NORTH POINT: See drawing	Revision:		PROJECT: Beach Road Apartments CLINT: Royalty Developments Dublin 4 Ltd. TITLE: "Proposed" Planting Plan ISSUE TYPE: Planning	DRAWN BY: RB CHECKED BY: DT PROJECT: S25 DRAWING NO.: BRA-PLA-Z0-00-DR-L-02100	DATE: 25/11/2022 REVISION NO.: A SCALE AT A0: 1:100
	A	Adjustment of tree area to bicycle stand area. Planter bed adjusted

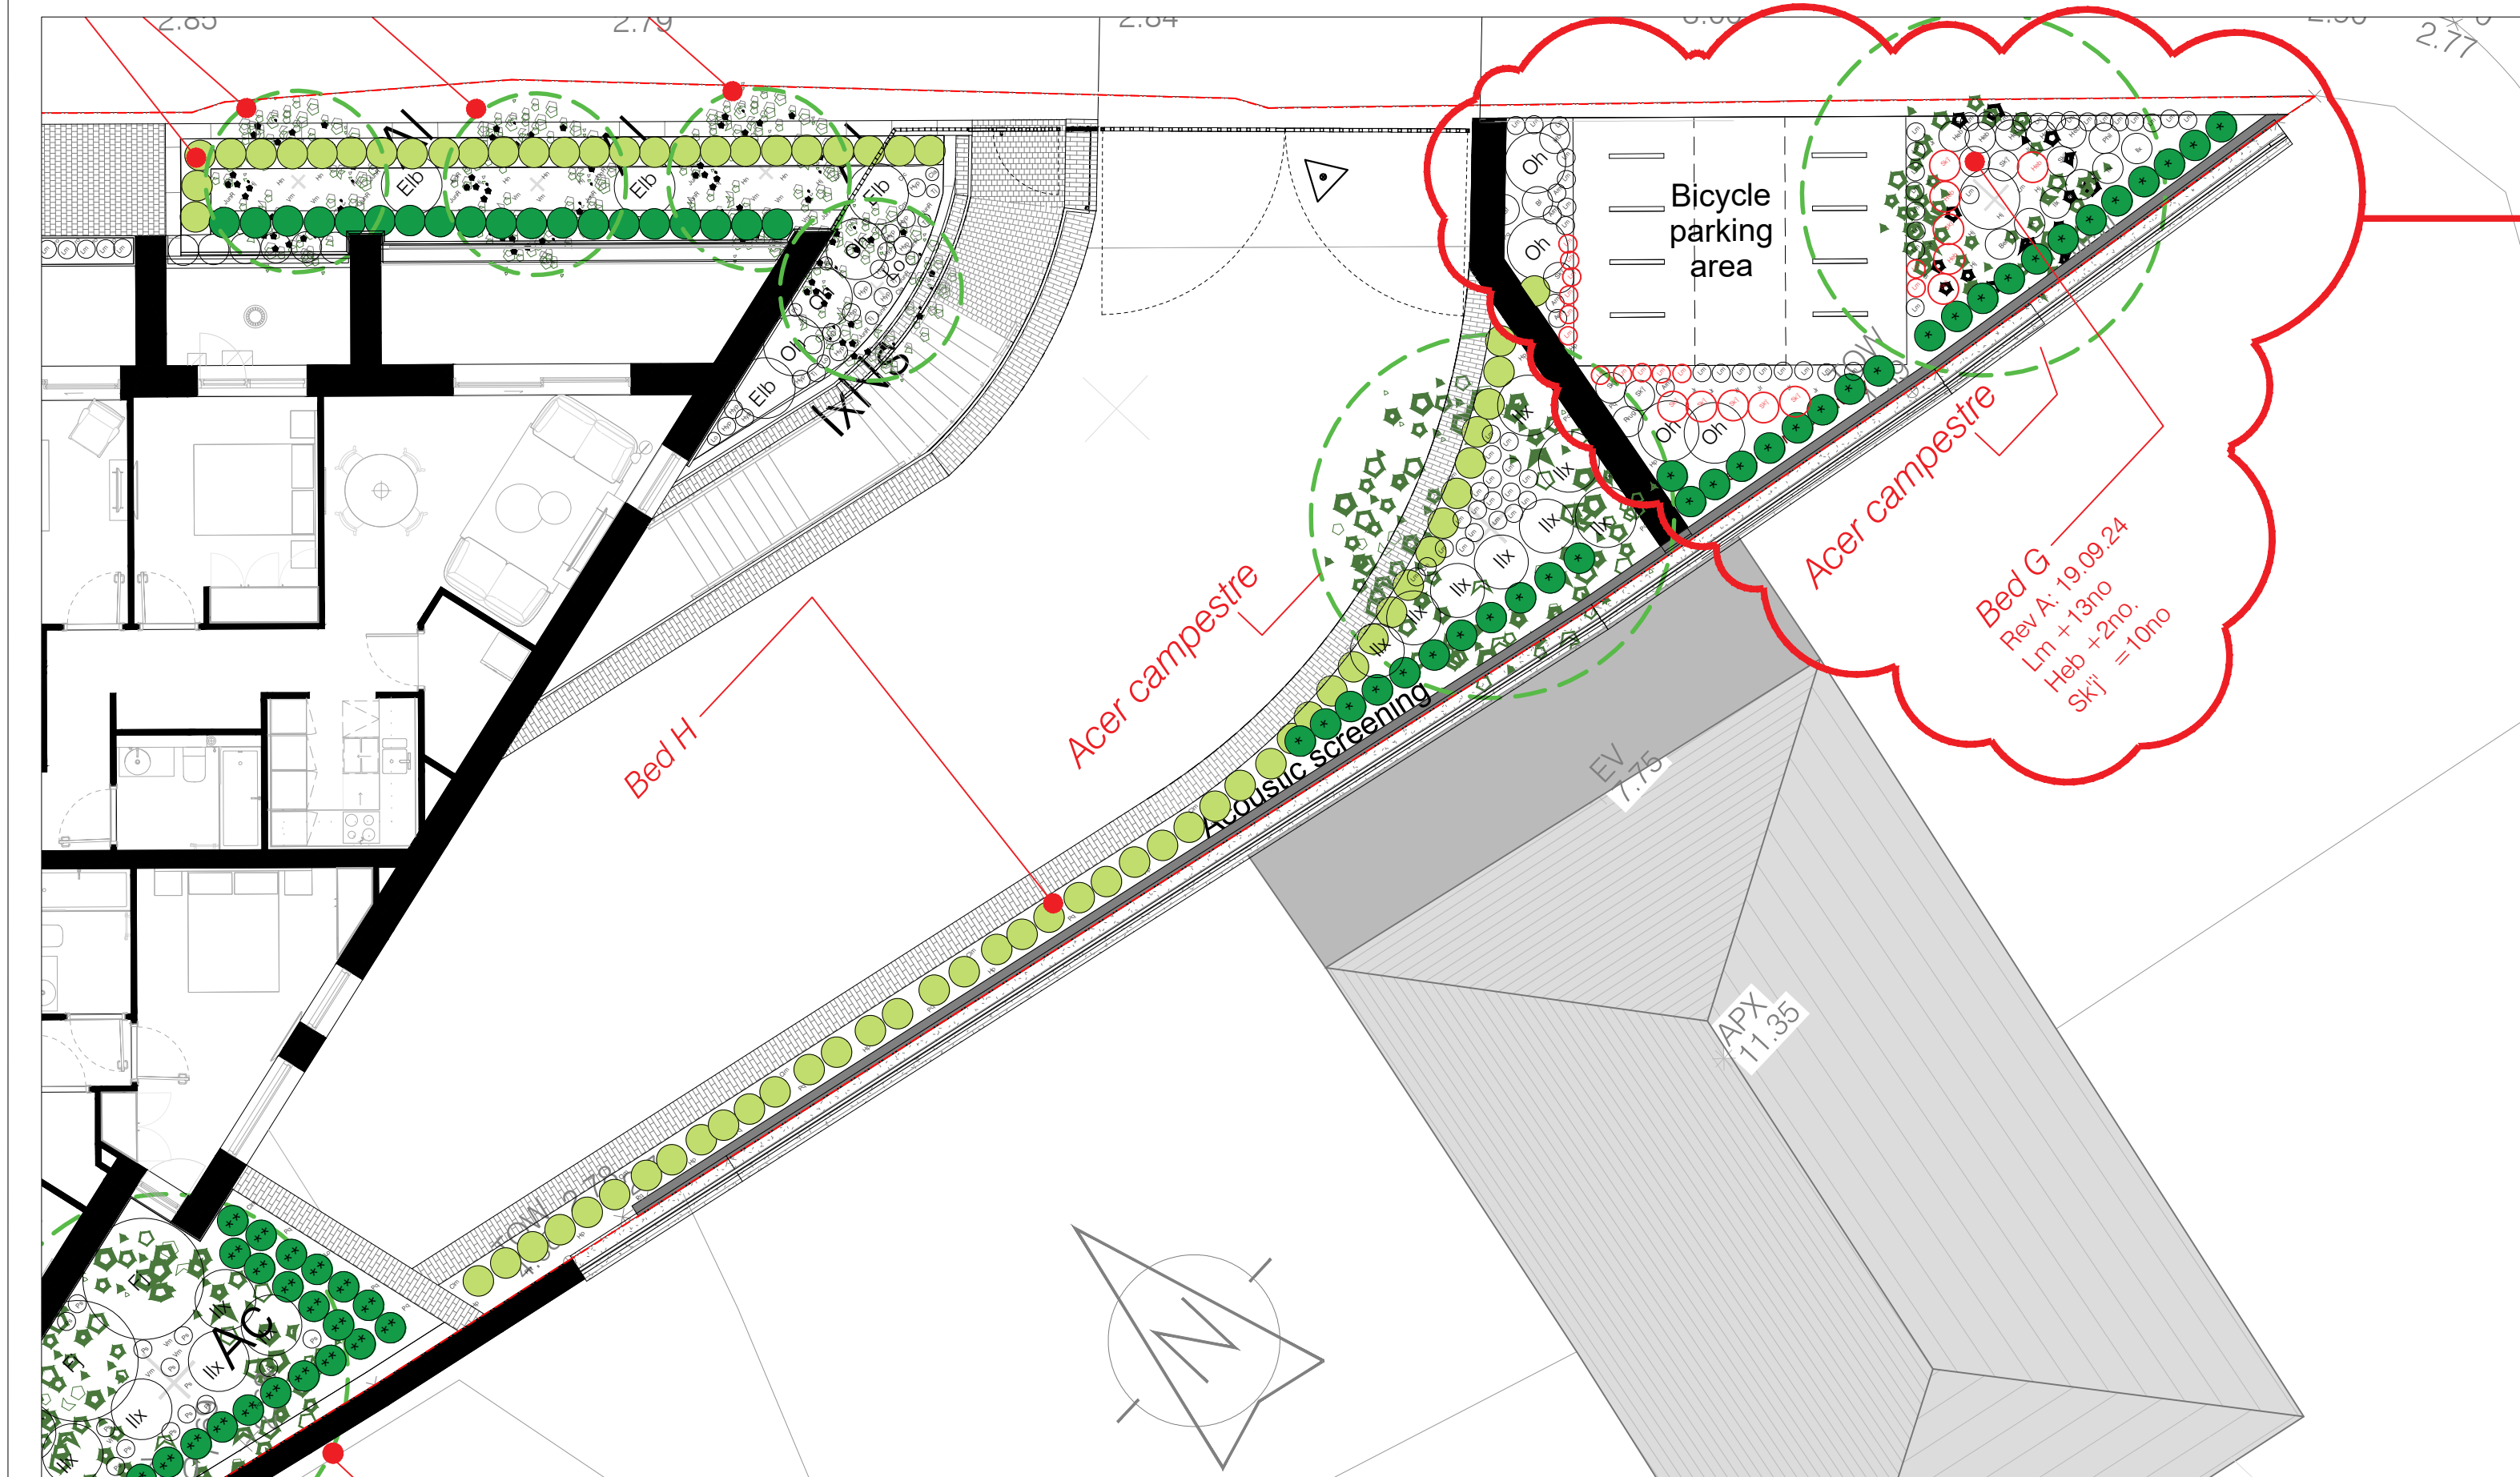
Rev A
Any planting additions
in red. Soil volume
remains the same but
reconfigured around
bicycle bays. Cell set out
remains the same as
previous drawing issued.
